Validation of Stream Diversion Design at Iluka Gingin Deposit

Iluka Resources Ltd

2 July 2008

42906853.W0009

Figure 3-2 SS1, SS2 & SS3: General layout

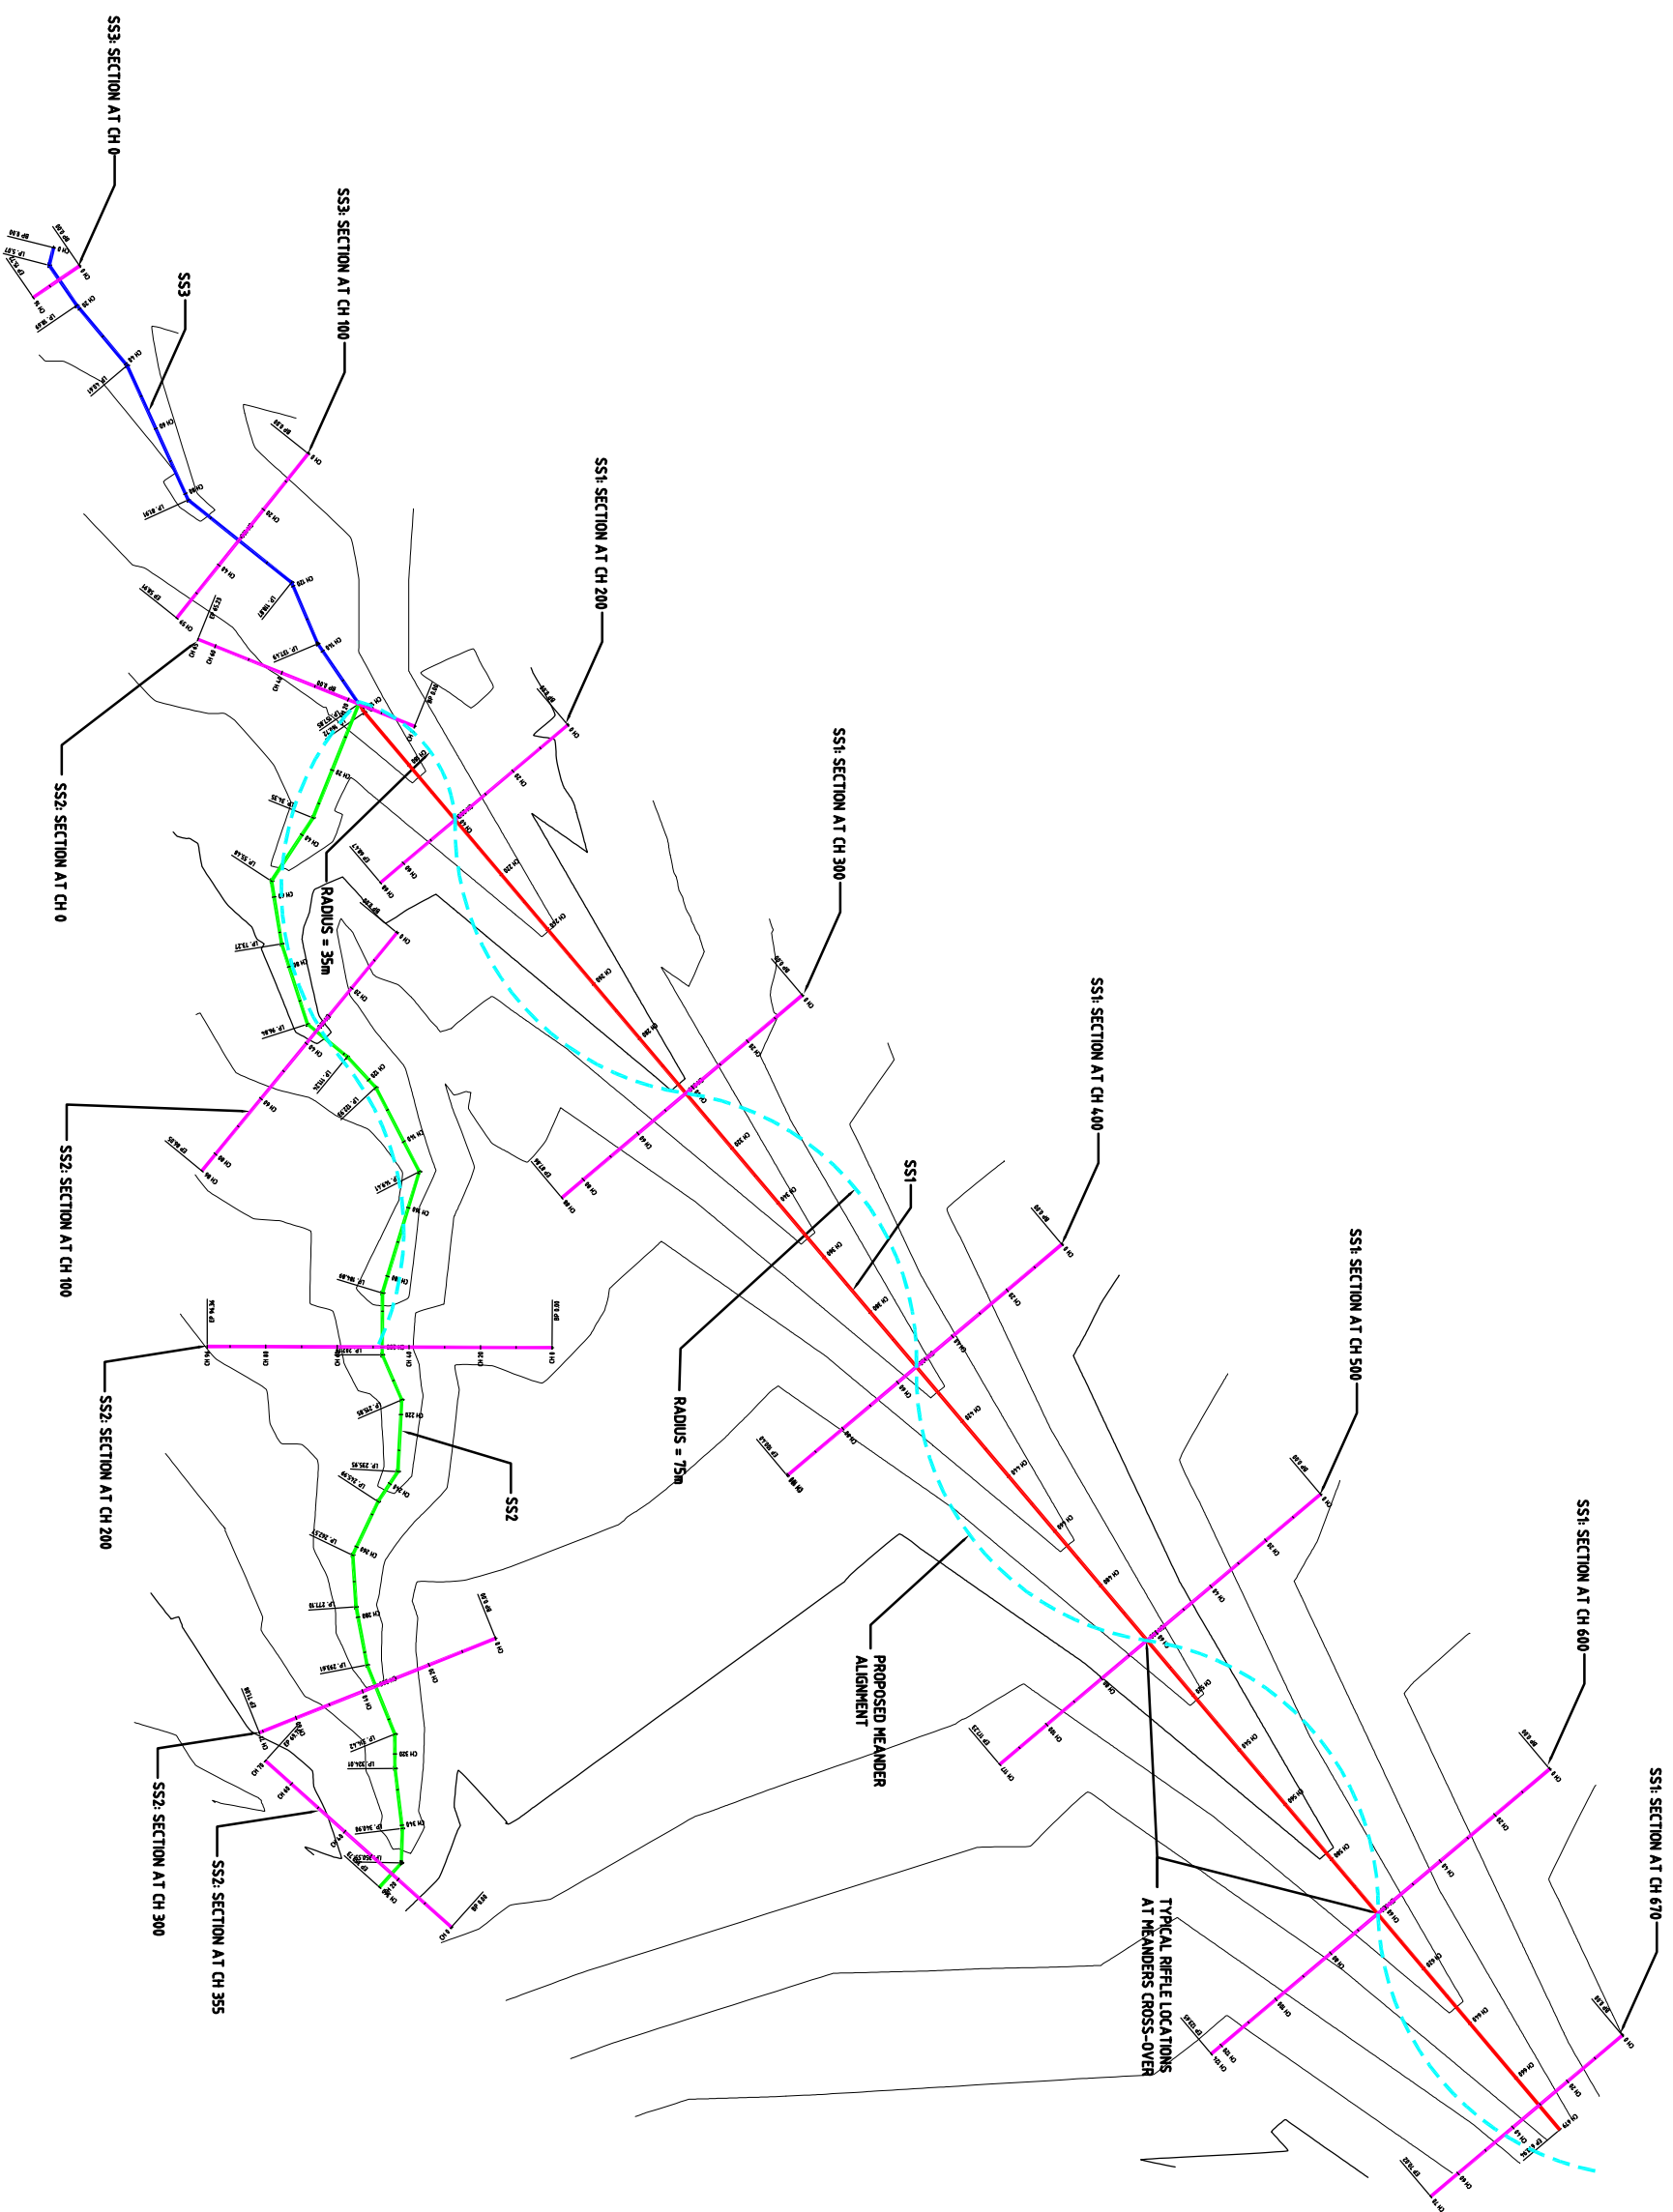
- Since the flow capacities are quite ample, there is some leeway to incorporate stream meandering to slow down the flow for erosion control. Most of the channel stretches of the original design already have some meandering except SS1 which is unnaturally straight.

- Meander wave length = 15 X Width of bankfull flow (upper limit) = 50 m
 - Radius of curvature = 2.3 X width of bankfull flow = 7 m
- It is also recommended in the guideline that meanders should be consistent with the flow alignments of similar sized streams in the same district. It has been found that the other tributary, Channel SS2 has a similar setting as SS1 in terms of catchment area, channel slope and landform. Measuring from the survey plan, the meandering in this SS2 channel has the following characteristics (Fig 3-2):

- Meander wave length = 200 m
 - Radius of curvature = 75 m
- It is suggested to adopt the same meandering features of SS2, as shown in Fig 3-2.

- Incorporate stream meandering (especially for SS1), taking advantage of the ample flow capacity.
- Incorporating Pool-riffle system in all channels, where appropriate.
- Provision of freeboard to take a 1:50 yr ARI flood flow – 150 mm for the smaller SS1 and SS2 channel and 300 mm for the larger SS3 and NS2.
- Provision of a low-flow section to confine the baseflow in the middle of the channel.
- Adopting the recommendations for stream reinstatement stipulated in Iluka Mine Closure Plan (Ref 2).

Figure 3-3 SS1, SS2 & SS3: Long Section Profiles & Cross Sections

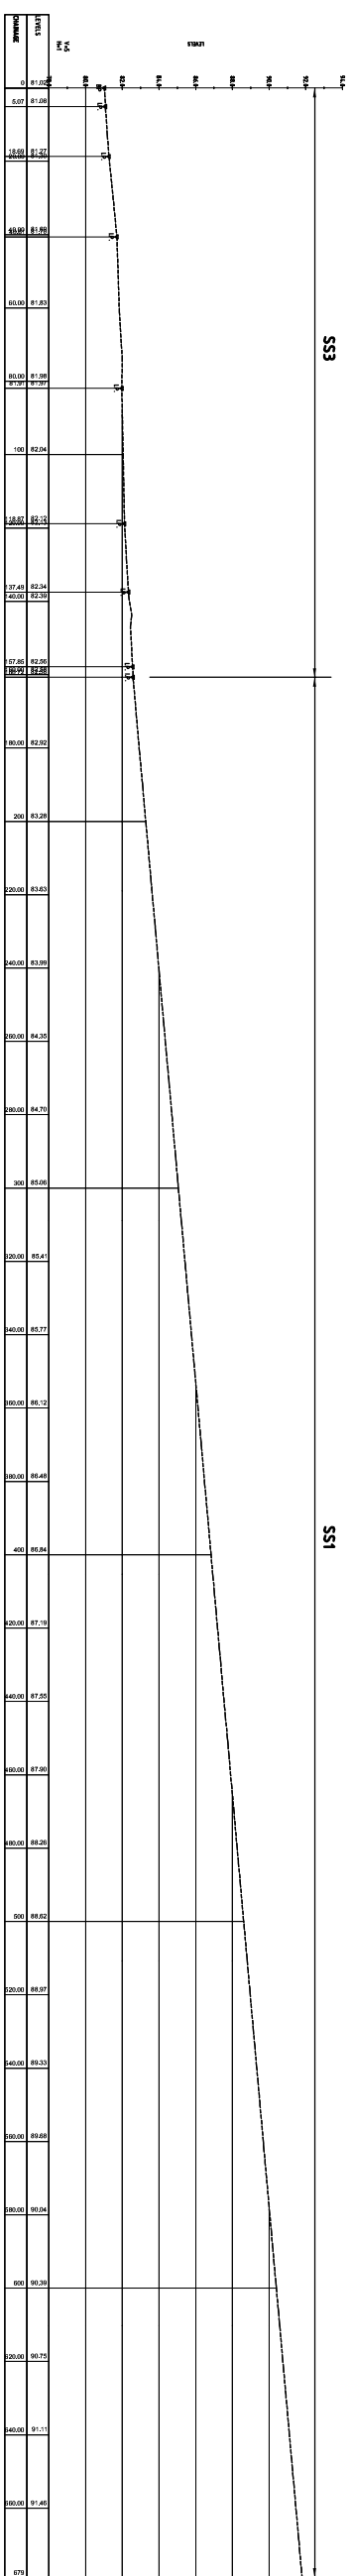
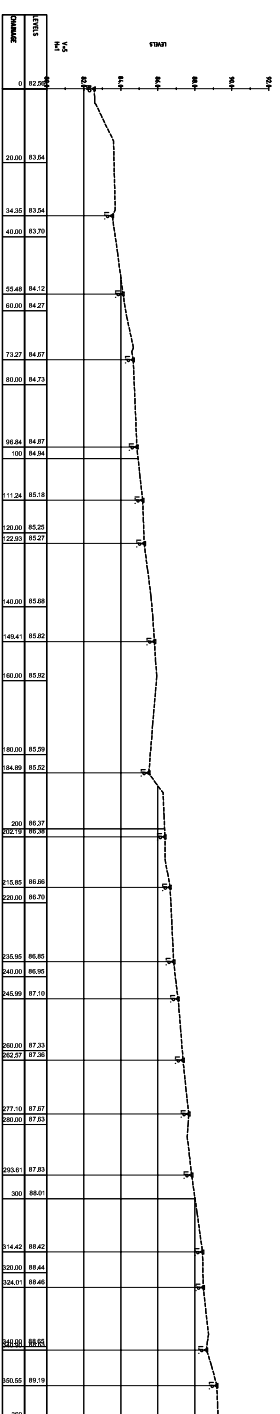
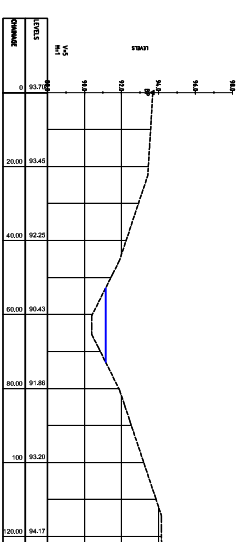
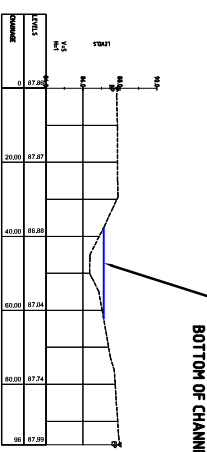
The two tributaries SS1 and SS2 have comparable characteristics in terms of catchment area, stream length, channel slope and peak discharge rates. Therefore it is suggested to adopt the same design for both channels. The design discharge rate has been rounded up to 6 m³/s. With the designed side slope of 1:2 and a bottom width of 5 m, the flow depth will be 0.75 m deep at the design discharge rate. This will be well contained in the design channel except at Ch. 355 m of channel SS2, where it will spill the bank. Some bunding or deepening/widening may be necessary at this location.

In general, the original design for the South Stream is adequate, except at Ch. 355 in channel SS2 which may need some bunding to contain the 1:20 yr ARI flow.

- The design sections for the South Stream are generally adequate, except at Ch. 355 in channel SS2 which may need some bunding, or deepened/widened to contain the 1:20 yr ARI flow.
- The triangular design section for the North Stream can not contain the 1:20 yr ARI flow. An alternative trapezoidal design section with a 5 m bottom width is recommended.

Figure 3-4 General Layout North Stream, Long Section Profiles & Cross Sections

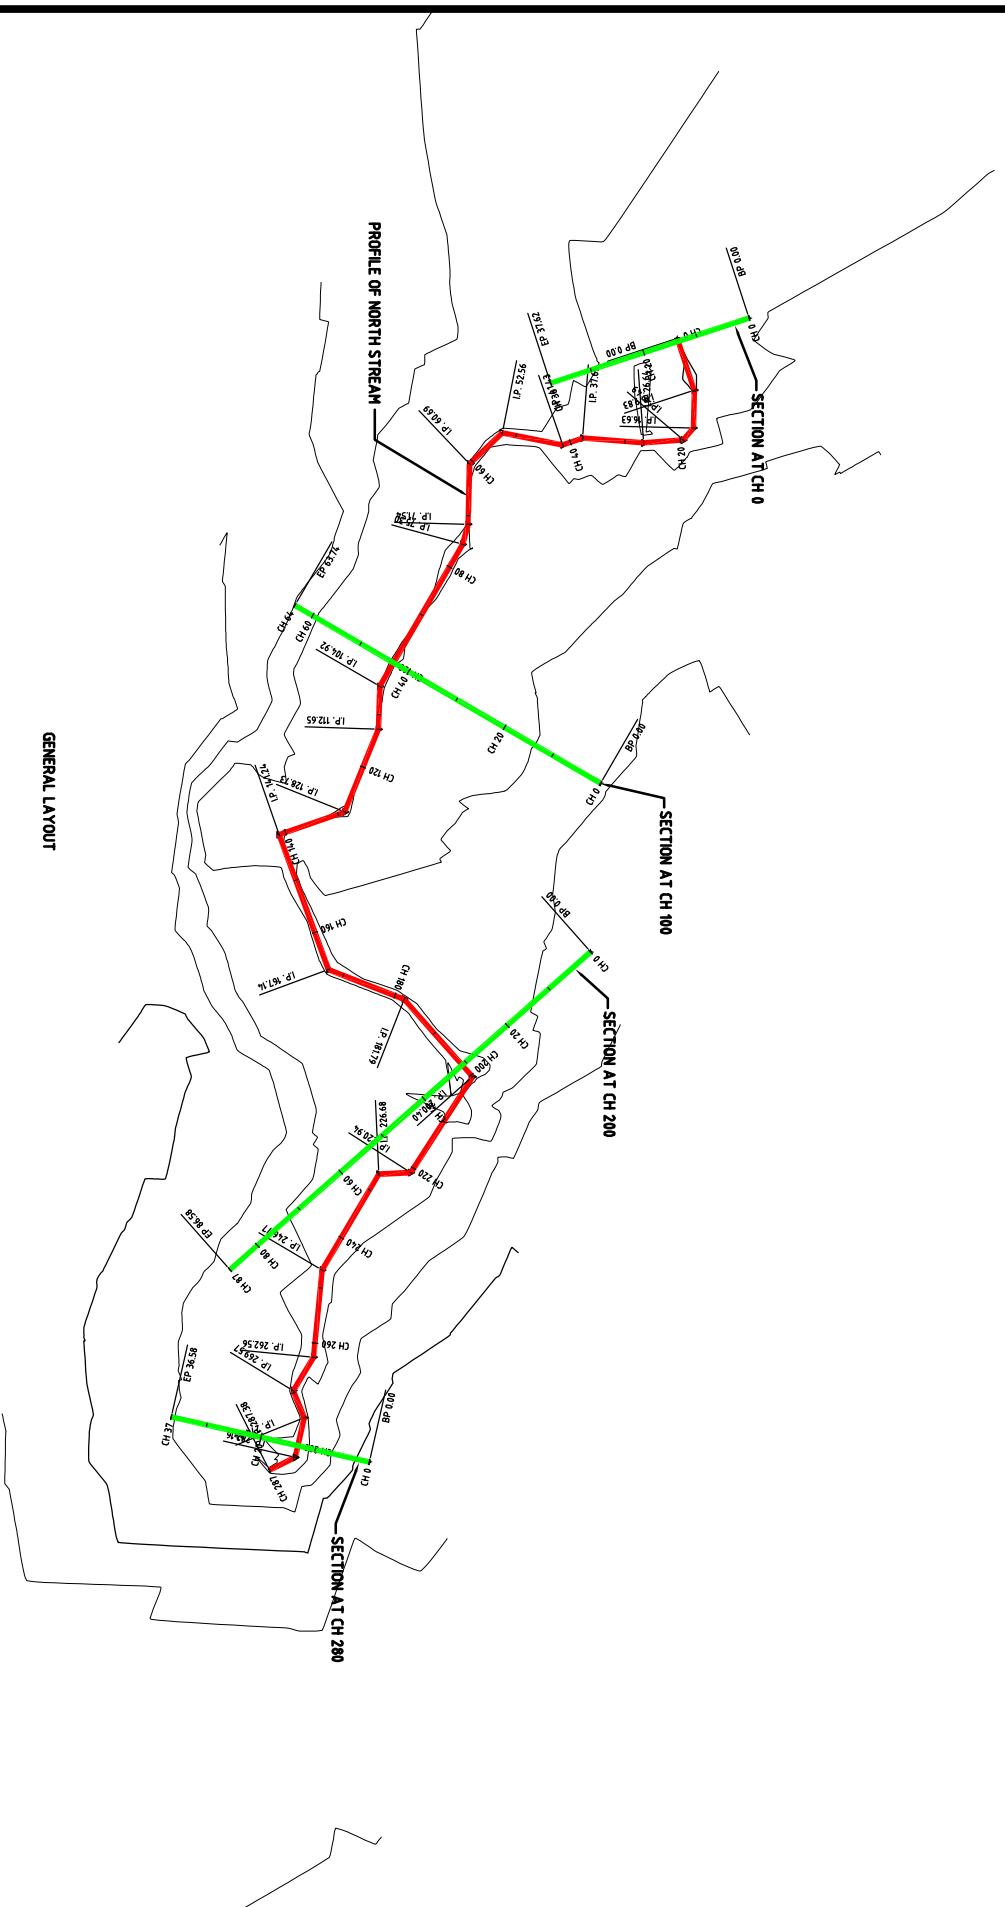
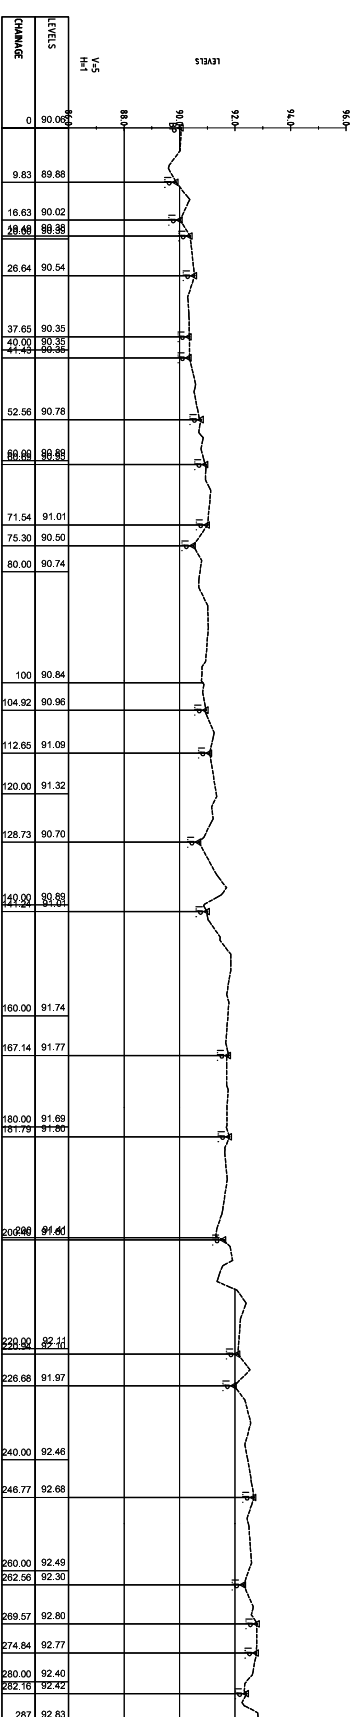
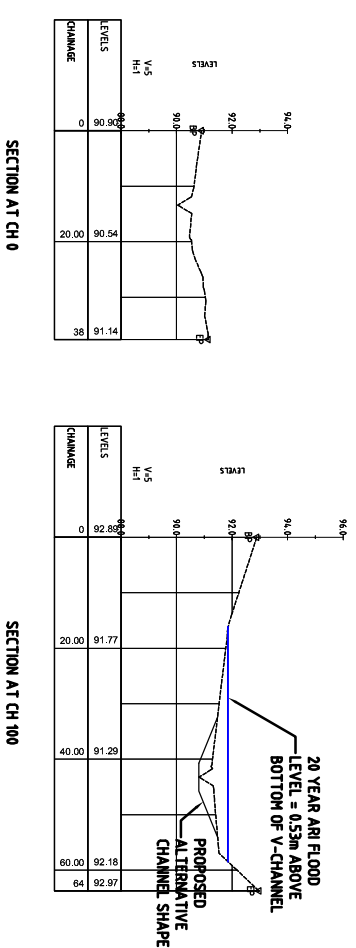
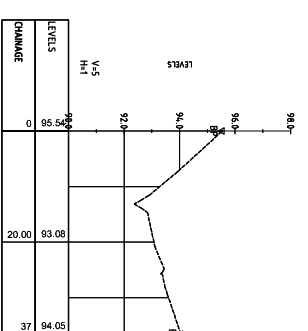
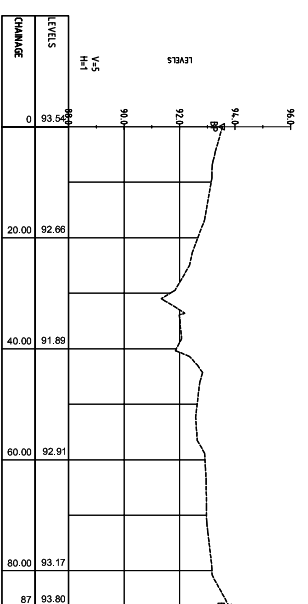
It seems from the result that the triangular low-flow section is insufficient for the 1:20 yr ARI peak discharge of 11 m³/s (rounded up to 12 m³/s for design purpose). The flood flow will inundate to the adjacent flood plain. The flood flow width will be approximately 60 m wide based on the typical section at Ch. 100m. The flow area required is about double compared to a case where the flood flow is contained in the stream channel. This is due to the much longer wetted perimeter of the flow section on the flat flood plain.

To avoid this low-efficiency flood flow regime, it is recommended to have a larger trapezoidal section with a 5 m bottom width as an alternative to the triangular section in the original design (see cross section at Ch. 100 in Figure 3-4). The flow characteristics of this alternative trapezoidal section are shown in the last column of the Table 3-5.
